F100A ANALOGUE ADDRESSABLE ELECTRONIC FIRE ALARM SYSTEM

Index, F100A LP Front Serv
PI399, Issue 3, 17-03-03
Pertronic Industries Ltd

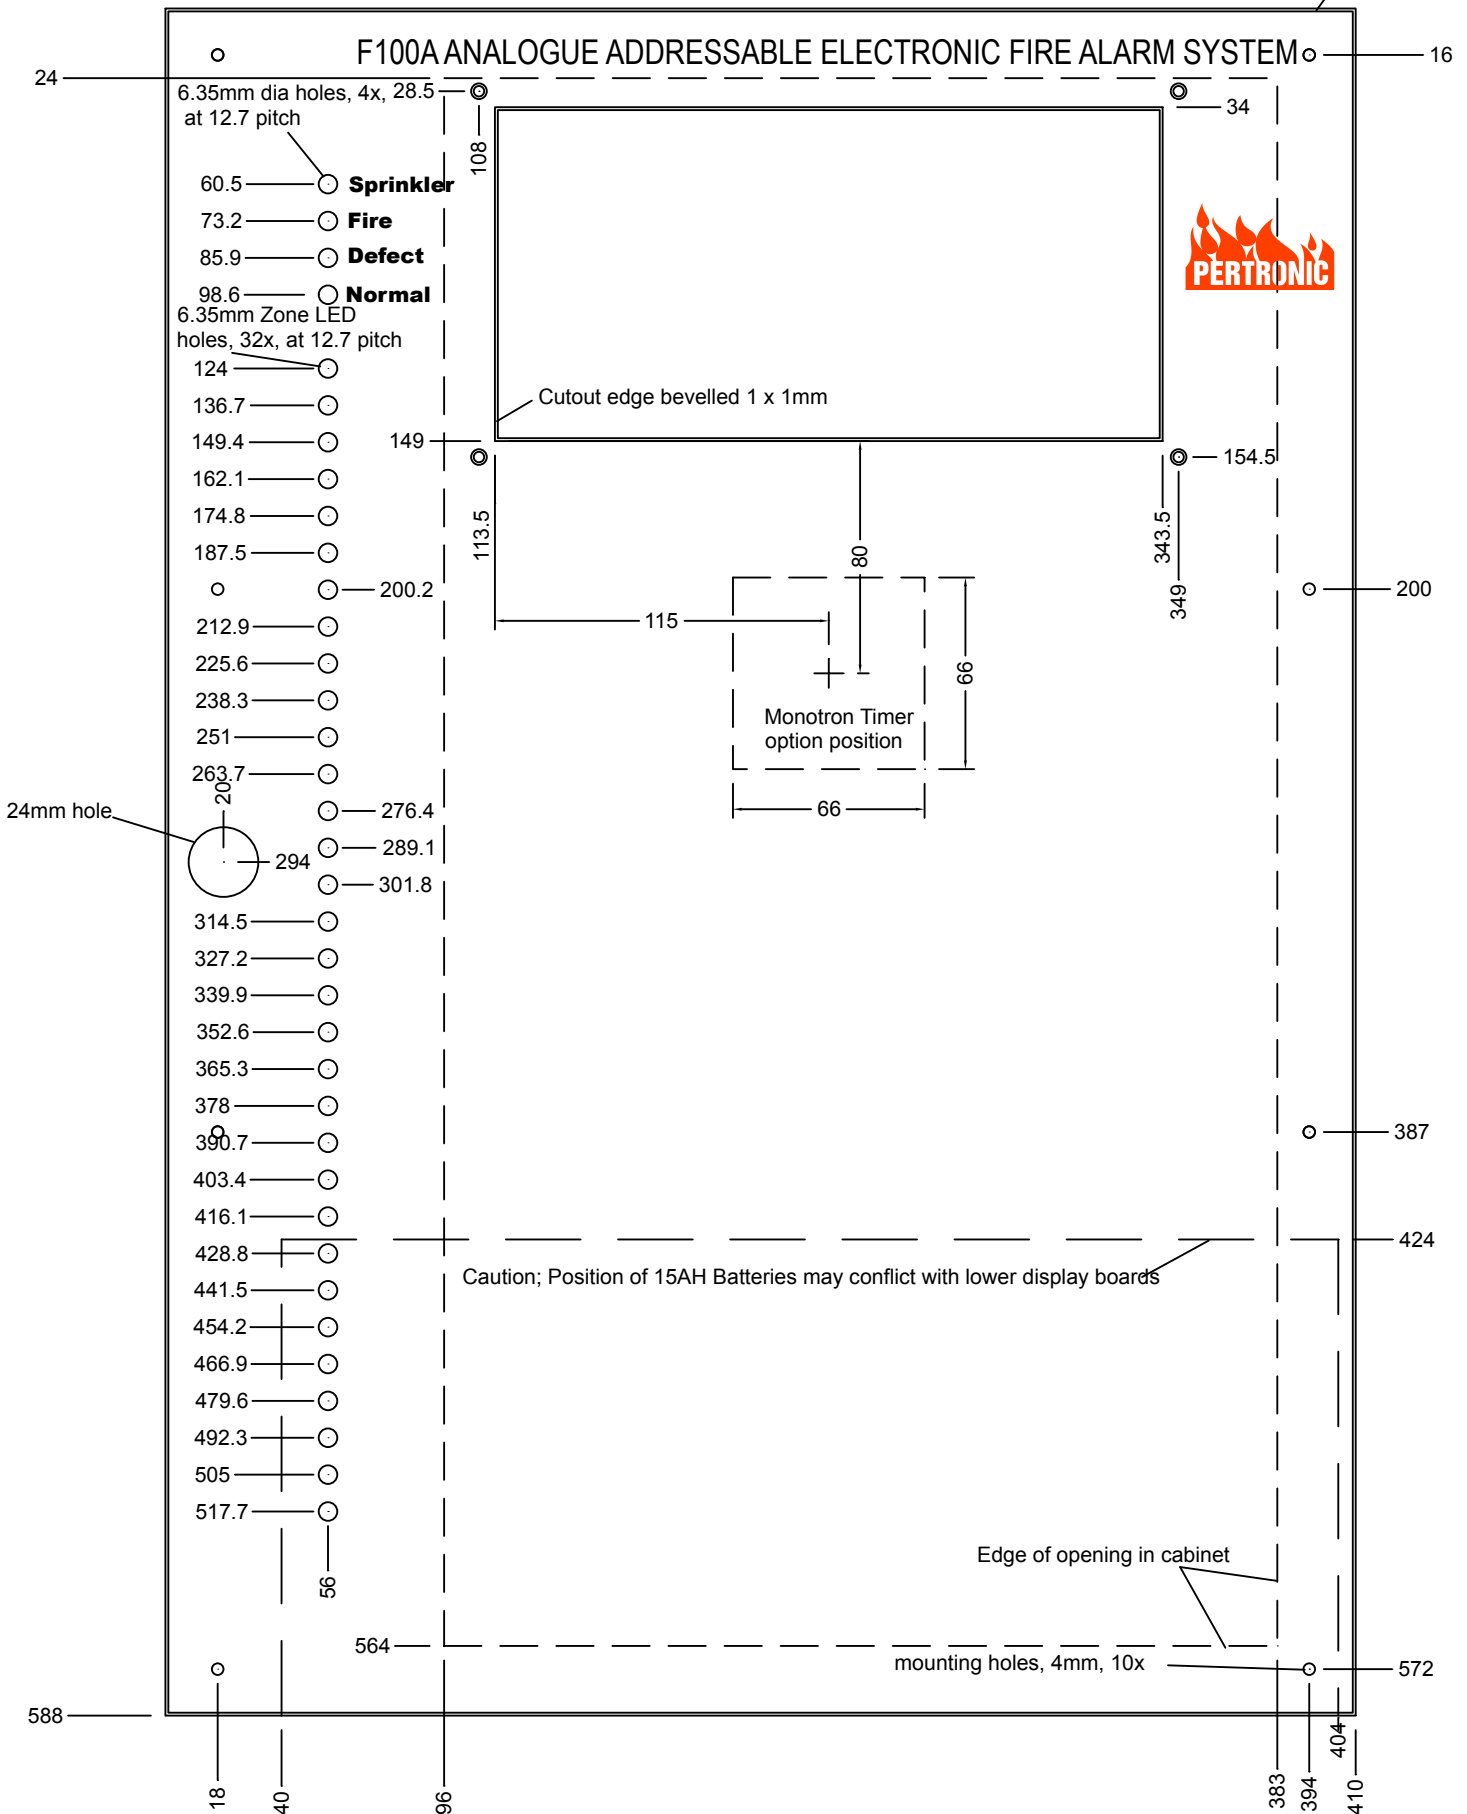
Issue 2 changes; Window & mounting holes moved 7.5mm to right, lock hole increased to 24mm dia
Issue 3 changes: countersinking on the eight mounting holes deleted & hole size increased to 4mm
